Your File No. : TPB/A/YL-NSW/366

Re : Renewal for the Temporary Private Swimming Pool and Garden Use for a Period of 3 Years in "Village Type Development" zone, at Lot. 3730 S.E (Part), 3733 (Part), 3734 S.A (Part), 3734 S.B ss.1, 3734 S.B RP (Part), 3734 RP (Part) & 3535 RP (Part) in D.D. 104, Pok Wai, Yuen Long.

SWIMMING POOL LAYOUT PLAN
(1 : 200)

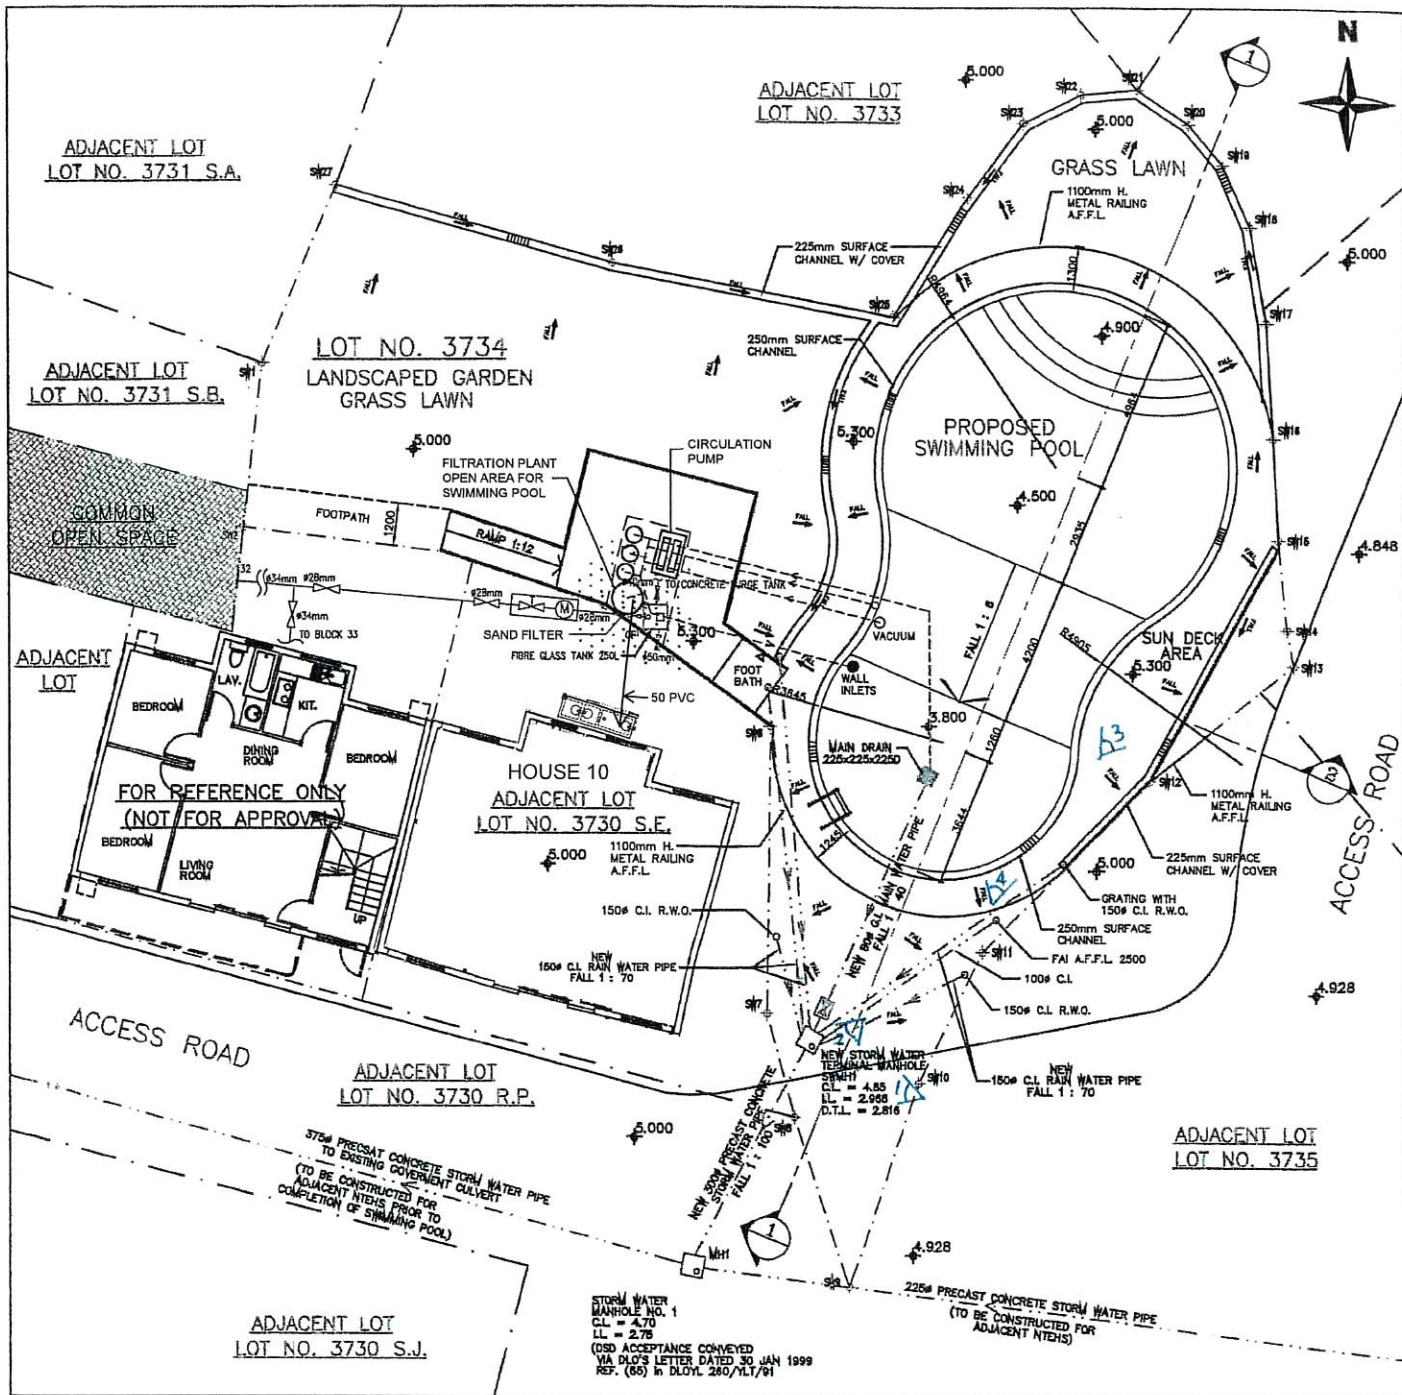
Item	Query	Our Reply
	Grateful if the applicant could confirm whether:	
i	Swimming pool main drain, footbath main drain and swimming pool make-up tank drain would be connected to storm water drains	We confirm.
ii	The filtration plant backwash would be discharged to foul sewers/suitable sewage treatment facilities.	Yes, the filtration plant backwash shall be discharged to septic tanks behind House H10
